Service Bulletin

No. : MZ07-092

Model: SR7400

Subject: Service Manual parts correction for 18000uF ELECT. CAP.

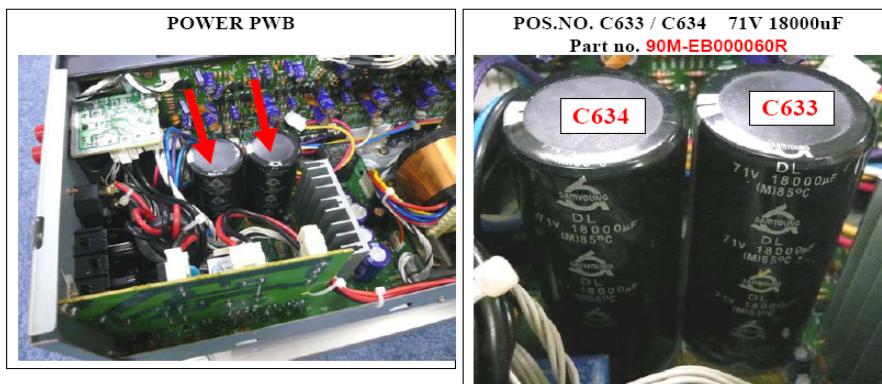
Symptom: The part number for ELECT.CAP 18000uF (POS. NO.C633 / C634) is incorrect in the Service Manual (Service Manual page 100)

Solution: The Old Part number: EB10907170 is for a 10,000uF cap. It cannot be used for POS.NO.C633 / C634. Use P/N: 90M-EB000060R (18,000 uF).
